U.S. Department of Energy
Office of River Protection

01-TOD-T023

**RESPONSE TO THE STATE OF WASHINGTON DEPARTMENT OF ECOLOGY'S
(ECOLOGY) ACTION ITEMS FOR CATCH TANKS 241-A-350, AZ-151, AND AX-152**

Tank A350

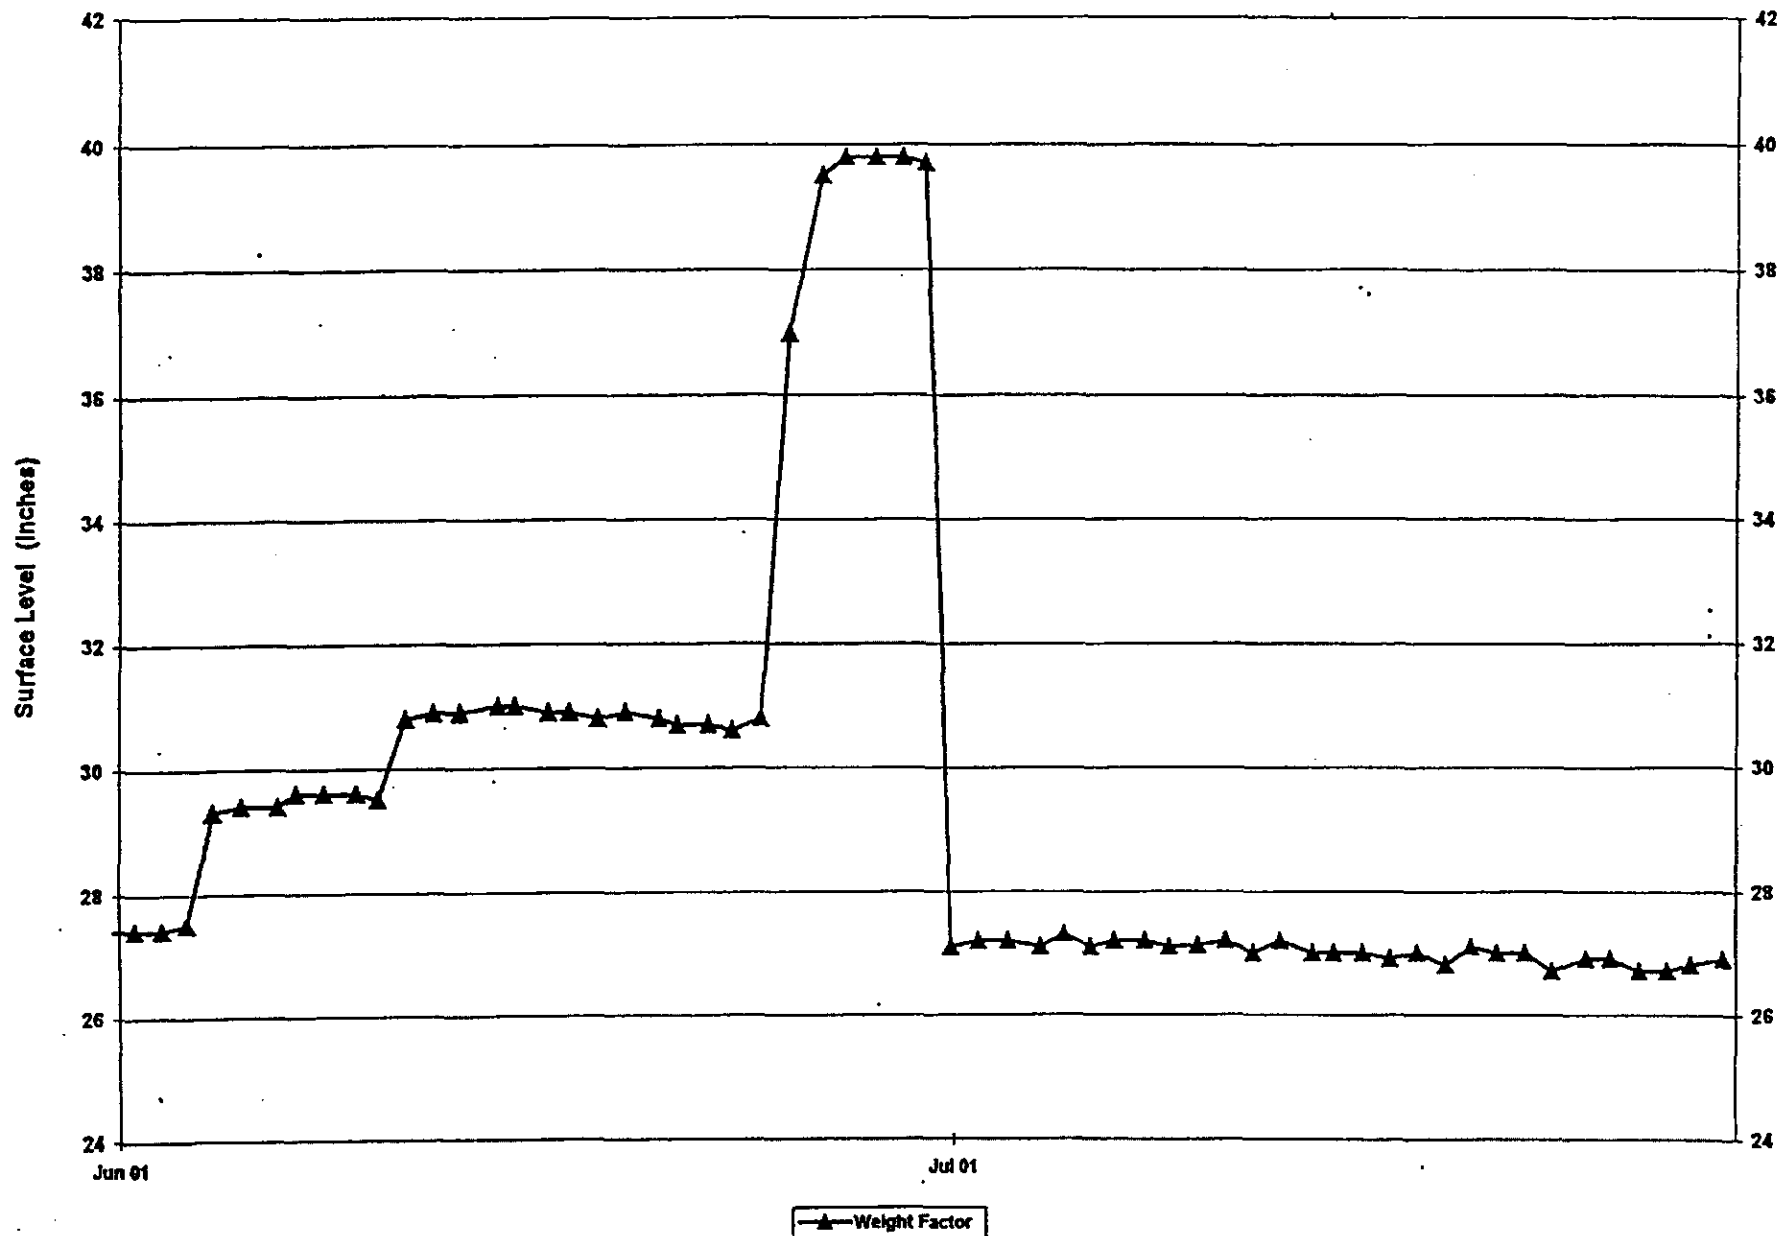
"Conduct static leak tests of AZ-151 and A-350 immediately and continue to conduct static leak tests of these catch tank systems annually thereafter, until these tank systems are removed from service. The USDOE may temporarily exceed operational safety limits for the sole purpose of conducting static leak tests in these tanks, as long as test liquids do not exceed the height of the primary tank's structure (i.e. tank liners, overflow outlets, or vaults)."

A static leak test of Catch Tank A-350 was recently recorded by tank level instrumentation during the period of June 25, 2001, to July 1, 2001. As shown in Attachment 1, the tank was determined not to be leaking. Per Action Item 1, this recent leak test meets the annual requirement of conducting annual static leak tests and will be conducted on an annual basis.

Tank AX152

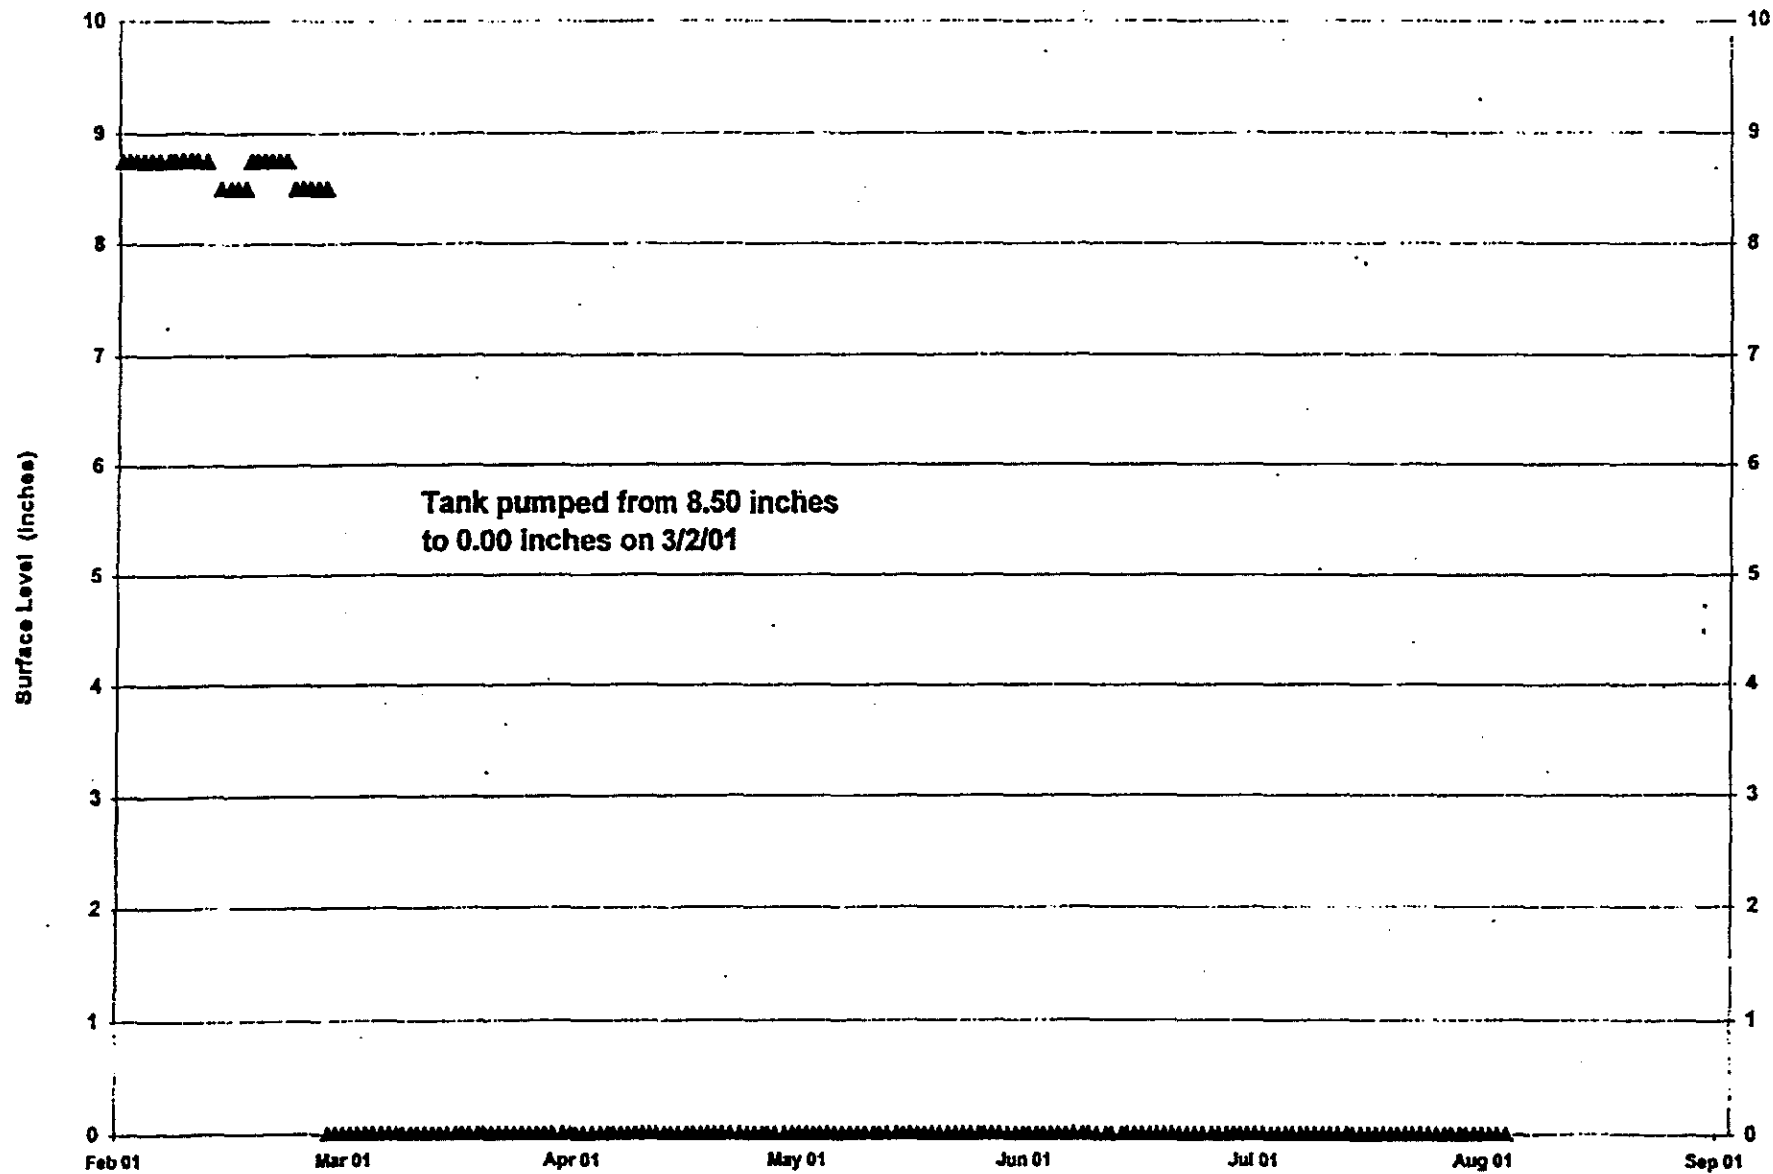
"By September 28, 2001, confirm that AX-152 is free of waste liquids and report these findings to Ecology. Liquids discovered in this tank system must be drained immediately."

Catch Tank AX-152 was declared a leaker by CHG's Plant Review Committee and removed from service in March 2001. The tank was subsequently drained of all liquid. As shown in Attachment 2, tank level measurements indicates the tank has been empty since March 2, 2001.

Tank pumped from 8.50 inches
to 0.00 inches on 3/2/01
